REPORT AMENDED BY CPC & STAFF 2-9-89
CITY PLANNING COMMISSION

APPLICANT BERLE CRISP, JTS ENGINEERING CONSULTANTS, INC. 1808 J Street, Sac., CA 95814
 OWNER Norwood LTD/Leasco Investors, 8455 Jackson Road, Sac., CA 95826
 PLANS BY Larry J. Schlichting 500 Cirby Way, Roseville, CA 95678
 FILING DATE 8/18/88 ENVIR. DET. Neq., Dec. REPORT BY BW:vf
 ASSESSOR'S PCL. NO. 237-0304-010

- APPLICATION:**
- A. Negative Declaration
 - B. Rezone 5.45+ vacant acres from Single Family Alternative (R-1A) to Multi-Family (R-2B) zone.

LOCATION: Northwest corner Norwood and Bell Avenue

Apartment/Elevations

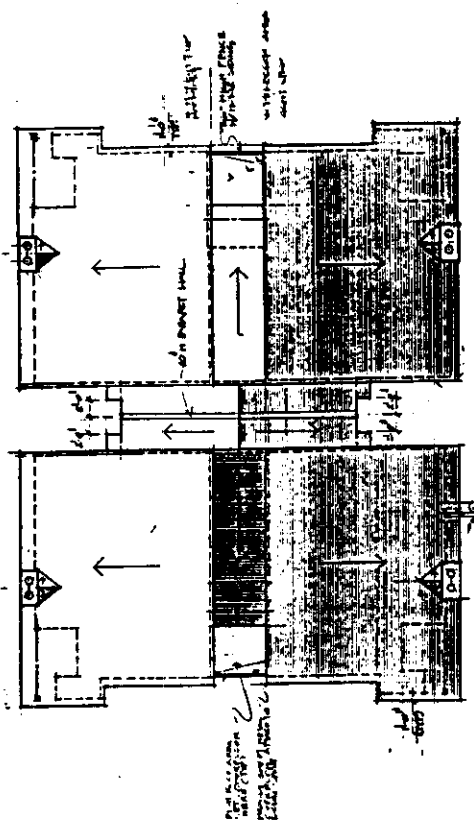
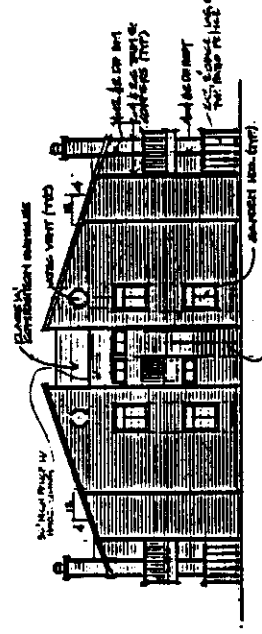
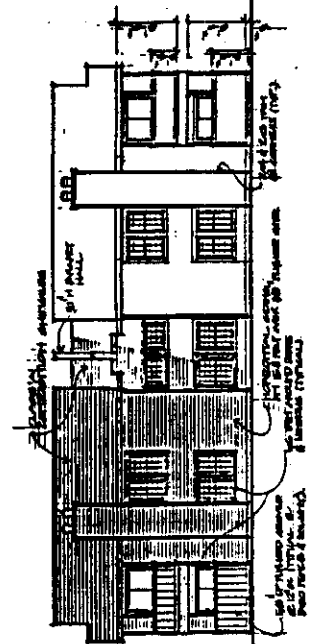
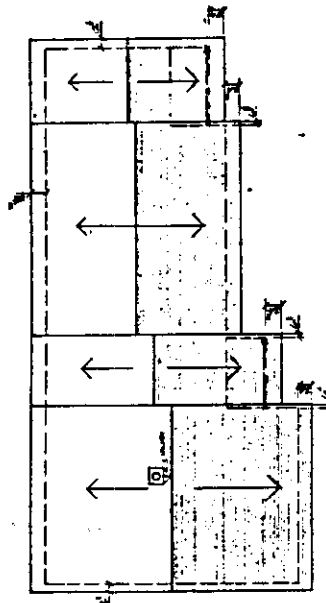
The building elevations for the development feature the use of horizontal plywood siding walls with grey and blue trim color. The roof material is made of composition shingles. Three bedrooms are proposed for the duplexes and two bedrooms are proposed for the apartment units. Planning staff and design review staff reviewed the proposed apartment, duplex and recreation structures and propose the following modifications:

1. Roofing materials shall be a 30 year architectural grade subject to Planning Director approval.
2. Exterior building material shall be made of horizontal wood siding or horizontal masonite siding. The masonite shall be a heavy thickness on all buildings.

3. The applicant shall provide six foot high wood fencing material between the duplexes to allow for privacy.
4. Building materials and coloring shall be reviewed and approved by the Planning Director. Each building shall have a body color and trim color and shall be two distinct colors.

5. All mechanical equipment (including public utility boxes and wall mounted air conditioning units) shall be attractively screened either through landscaping or fencing.

6. Patio fences and balcony railings shall be solid for privacy and to screen material stored on the interior from public view.
7. The proposed parapet wall on the apartment buildings shall be covered in a material to match all other exterior walls of the structure.
